# ***SERVICE PROCEDURE***

20510  
January 2021

**SUBJECT: SAFETY RECALL**

Figure 2  
1 Send to ECM button

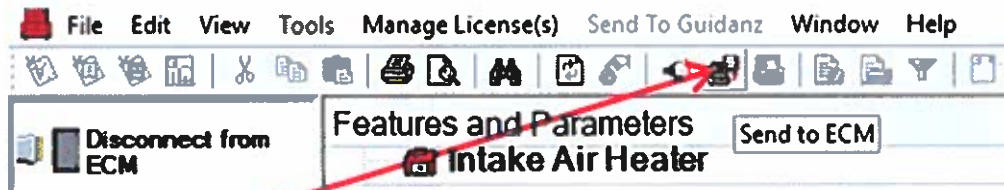
12. Select the Send to ECM button (Figure 2, Item 1) from the menu table at the top.
13. Once send has completed, turn ignition key to off position and wait 30 seconds.
14. Turn ignition key to on position, engine off and verify parameter settings have been saved.
15. Disconnect EZ-Tech from vehicle.
16. Remove battery charger / maintainer from vehicle battery.
17. Turn ignition key to off position.
18. Remove wheel chocks.
